EPSDD - Request for Further Information

22 May 2024

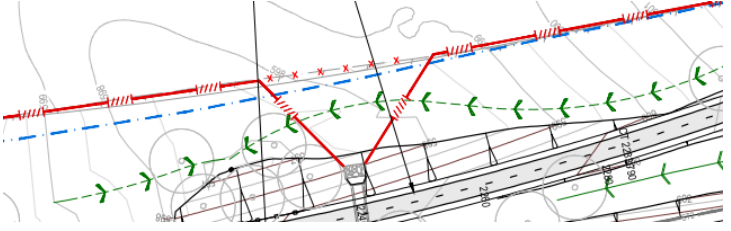
Item No.	Agency/Person	Comment	Proponent Comment
1	Conservator of Flora and Fauna	Shared path amendments: It is unclear whether the safe movement of cattle across William Hovell Drive into Kama Nature Reserve has been addressed. The proponent needs to consult with Mark Hartman regarding this issue.	<p>Please refer to the attached drawing package which includes the 100% detailed design drawings, which have been prepared whilst consideration of the DA and EIS has been underway.</p> <p>The design of the underpasses has been modified in response to the comments received from Mark Hartman, the grazing lessee. One of the underpasses is now suitable for cattle movement and this comment has now been addressed.</p>
2	Conservator of Flora and Fauna	Shared path amendments: The construction boundary adjacent to the Kama Nature Reserve appears unnecessarily wide, particularly in pavement sheet 7 and 8 (2000-2380). In these areas, the construction boundary must be restricted as much as possible.	<p>This has been refined as part of the 100% design process. Please refer to the attached design drawings and snip below.</p>
